Access Compliance Report

Public Rights-of-Way

(Curb Ramps)

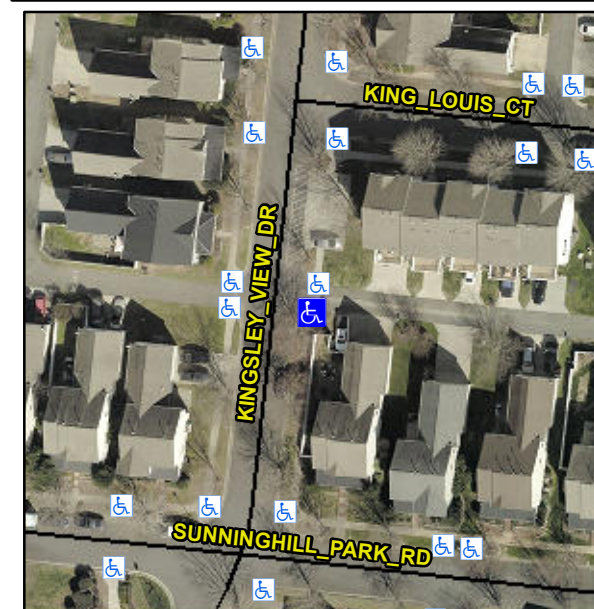
Intersection ID: 10029691	Main Street: KINGSLEY_VIEW_DR	Cross Street: N/A	Location: SE
ADA ID: E77DC097C9F0	Ramp Type: BlendTrans1	Initial Pass/Fail: Fail	Overall Compliance: No
Severity Score: 36.25			
Codes/Mitigation Info/Possible Solution		Field Measurements/Component Compliance

Not Found, R304.5.1

Compliance	Description	Data	Compliance	Description	Data
N/A	Ramp Length (in)	77.0	Yes	BlendTrans Slope (%)	3.4
No	Ramp Width (in)	25.0	Yes	BlendTrans XSlope (%)	2.6
N/A	Flare Type LT	N/A	N/A	Flare Type RT	N/A
N/A	Flare Slope LT (%)	N/A	N/A	Flare Slope RT (%)	N/A
N/A	Flare Traversable LT?	N/A	N/A	Flare Traversable RT?	N/A
N/A	Landing Length (in)	N/A	N/A	DWS Provided?	N/A
N/A	Landing Width (in)	N/A	N/A	DWS Contrast?	N/A
N/A	Landing Slope (%)	N/A	N/A	DWS Length (in)	N/A
N/A	Landing X Slope (%)	N/A	N/A	DWS Full Width?	N/A
N/A	Landing Curb? (Y/N)	N/A	N/A	DWS Offset (in)	N/A
N/A	Shared Landing?	N/A			
N/A	Gutter Ponding?	N/A	N/A	Gutter Slope (%)	N/A
N/A	Gutter Lip Ht (in)	N/A	N/A	Gutter X Slope (%)	N/A
N/A	Painted X Walk1?	No	N/A	Painted X Walk2?	No
	X Walk 1 Direction	To N		X Walk 2 Direction	To W
	X Walk 1 Width (in)	N/A		X Walk 2 Width (in)	N/A
	X Walk 1 Slope (%)	1.1		X Walk 2 Slope (%)	2.2
	X Walk 1 X Slope (%)	0.5		X Walk 2 X Slope (%)	3.4

N/A	Ramp inside XWalk1?	N/A	N/A	Ramp inside XWalk2?	N/A
	Road Slope (%)	3.1		Clear Space?	N/A
	Road X Slope (%)	0.5	N/A	Clear Space to XWalk (in)	N/A
N/A	Any Obstructions?	N/A	N/A	Storm Grate/Utility Hazard?	N/A
	Obstruction Type			Storm Grate/Utility Type	
		N/A			N/A
			Yes	Surface Condition? (G/P)	Good
			No	Curb Slope (%)	12.1

Remove & Replace Curb Ramp With Two New Directional Ramps or Equivalent.
